REQUEST FOR PROPOSAL (RFP)

Camanche North Shore Open Berth 25-492-01 Response to Questions Post Job Walk

June 30, 2025

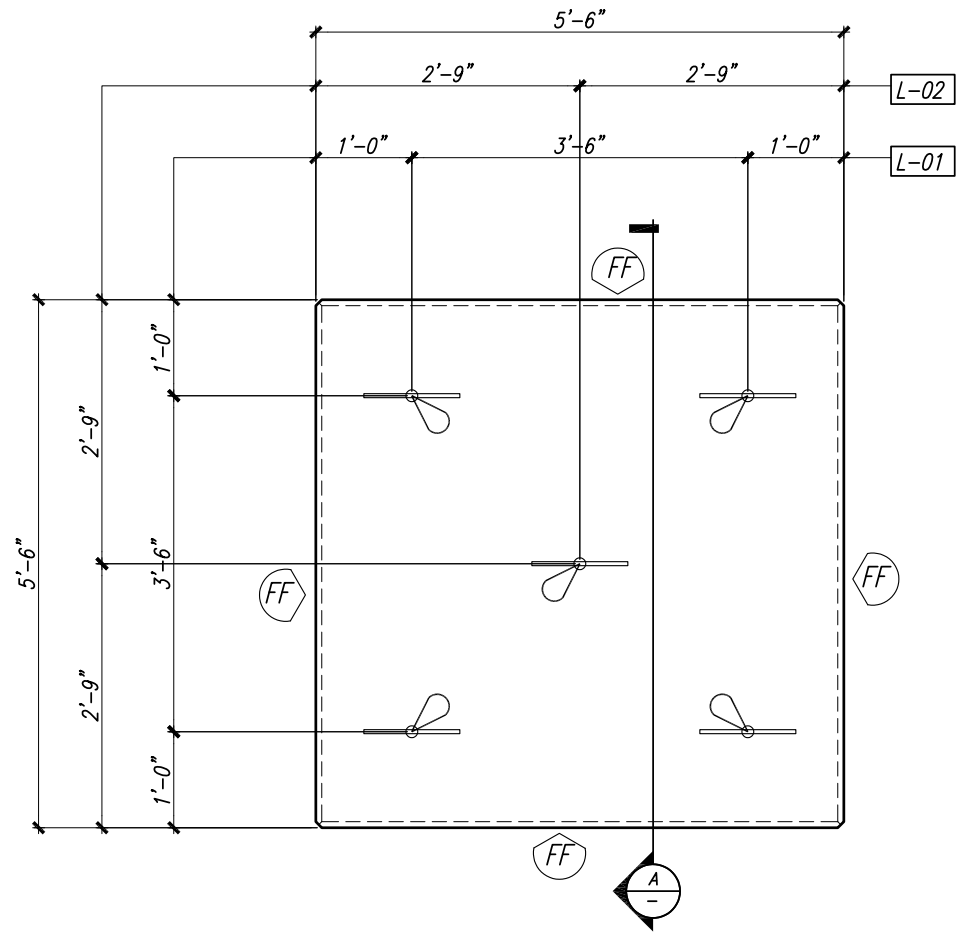
Q.16) **12. Water Depths**

- **Issue:** RFP does not specify water depths at the project site
- **Question:** What are the water depths at the proposed dock installation location? Can the Owner provide bathymetric survey information and bottom conditions for the project site?
- During the pre-bid meeting it was mentioned that EBMUD has a depth survey they will be providing bidders. Please send so bidders have time to evaluate.

A.16) Pictures and depth measurements are attached.

Note: The photo is from (July) **2014**. The proposed dock location should follow a heading of **176.53° (267 feet of dock)**.

Following that exact heading, the depth measurements are as follows:

West Side of Dock East Side of Dock

9'	14'
18'	19'
55'	36'
56'	29'

JOB NAME:
TMC MOORING BLOCK

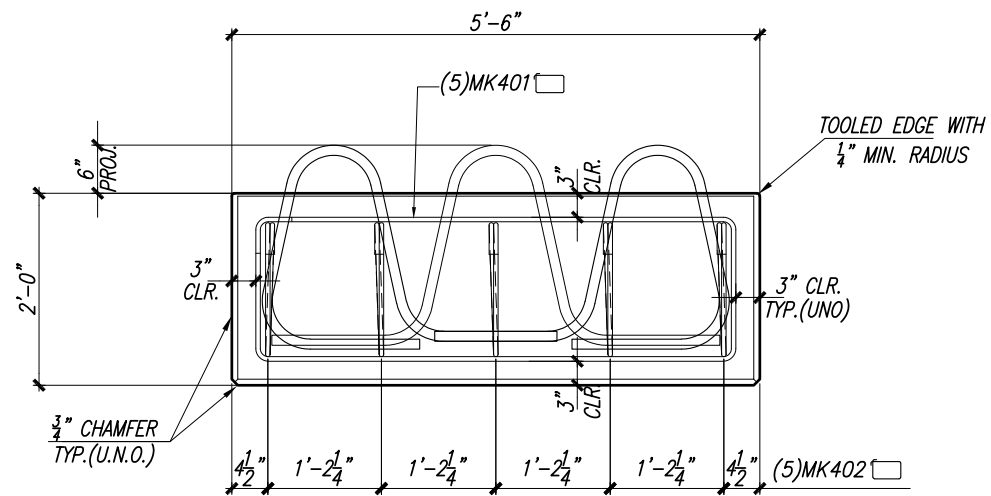
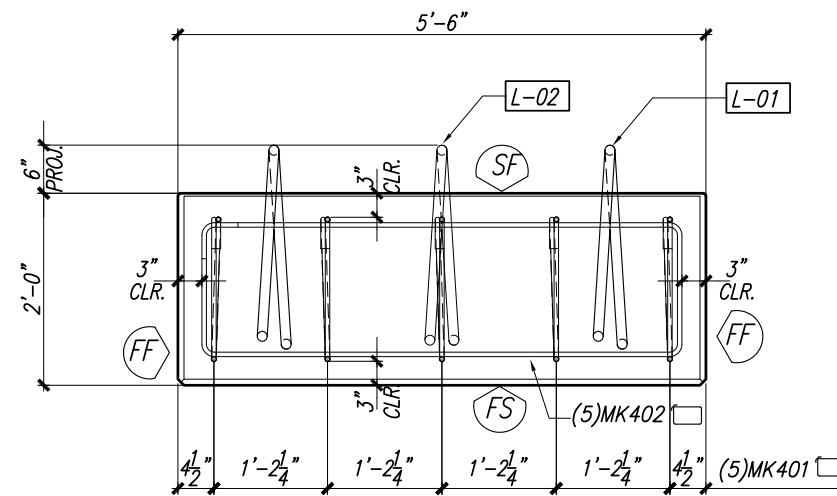
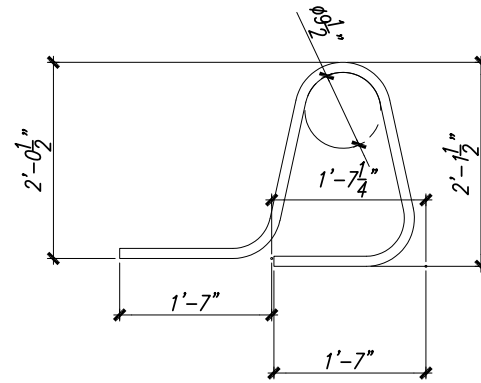
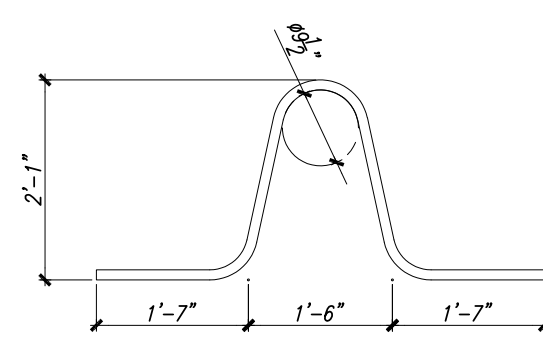
Q.19) **15. Anchor Layout/Design**

- During the pre-bid meeting, EBMUD indicated that EBMUD will be providing the concrete anchors of 9,000 lbs. A total of 8.
- **Question:** Please confirm who is responsible for the anchoring design. If EBMUD is dictating the anchor size and amount, is EBMUD taking all design responsibility for the dock system if the anchoring size/amount prove to be insufficient? Is EBMUD providing the 5/8" cable and Wintech Winches in the Pre-Bid Meeting.
- **Question:** It was indicated that EBMUD is installing the anchoring system for the new dock system. Can EBMUD confirm that EBMUD will take **ALL** install and design responsibility of the anchoring system?
- **Question:** During the pre-bid meeting EBMUD indicated that they have photos and a design of a 9,000 concrete anchor block. Can EBMUD send this info to the bidders?

A.19) Technical drawings of the currently used anchors at Camanche will be attached. EBMUD will provide the quantity of anchors indicated as necessary by the builder. The current docking systems at Camanche include Wintech winches with 150' of galvanized 5/8" cable. We are requesting the builder to include the adequate amount of comparably sized Wintech winches installed on the designed docking system.
